Re: White Diamond, 312 Florida St.

**Submittal for Certificate of Occupancy – Transportation Development**

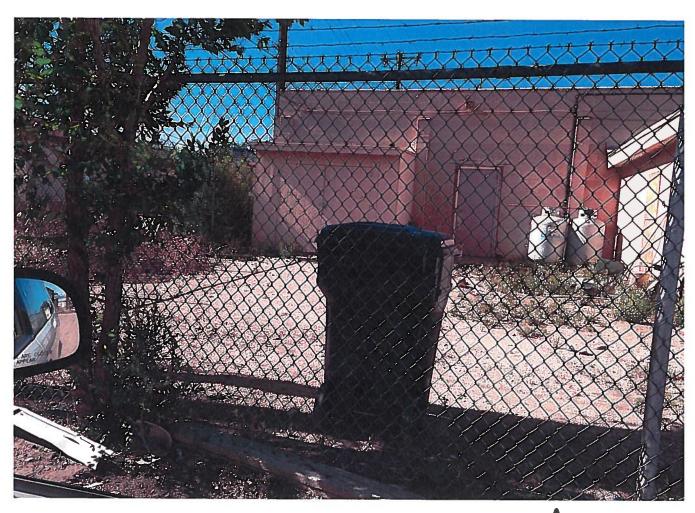
- 2. There is no way to access the proposed three parking spots located in the northeast corner of the site. Please provide clarification if the chain-link fence will be removed.
- 3. Unused curb cuts need to be replaced with standard curb, gutter and sidewalk.
- 4. A Wheelchair accessible parking space sign was affixed to the west side of the building. This is not an appropriate place for parking and as such it should be removed.
- 5. All parking bumpers shown on the plan should be installed.
- 6. "NO PARKING" should be painted in large letters on the wheelchair access aisles.
- 7. Please indicate on the plan where the main entrance is. Signs on the doors did not make it clear where the accessible route is located.

How are you supposed to park here?
